AKTV8

Details of Changes Made to the Product

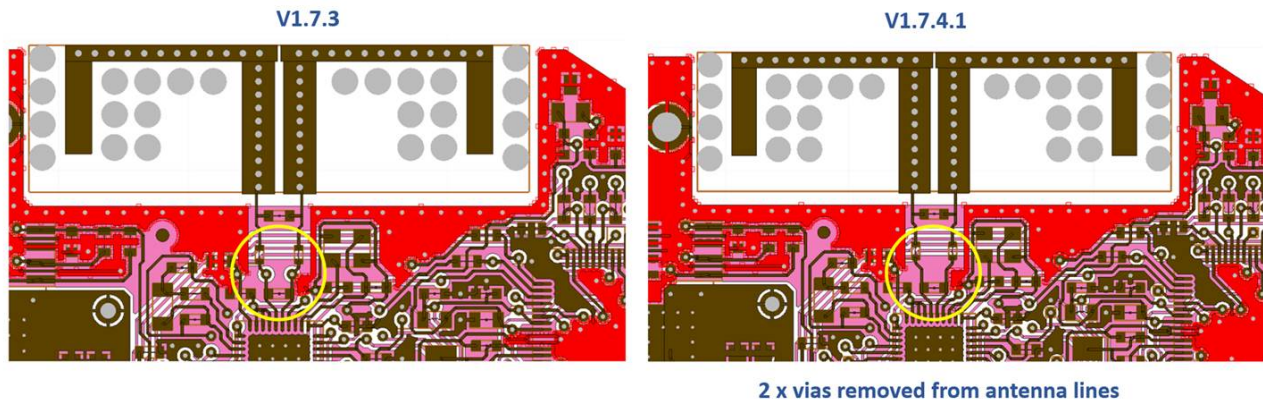
The originally certified product (hardware version v1.7.3) is being updated (to new hardware version v1.7.4.1) by (1) removal of two test vias in the RF traces and (2) the addition of copper pads and a pull up resistor for future compressor control (digital circuitry). To remain compliant, the transmit power setting in the sample has been decreased to the next lower setting. The product labeling including model name (Model/HVIN: iAir3) remains the same.

(1)

(2)
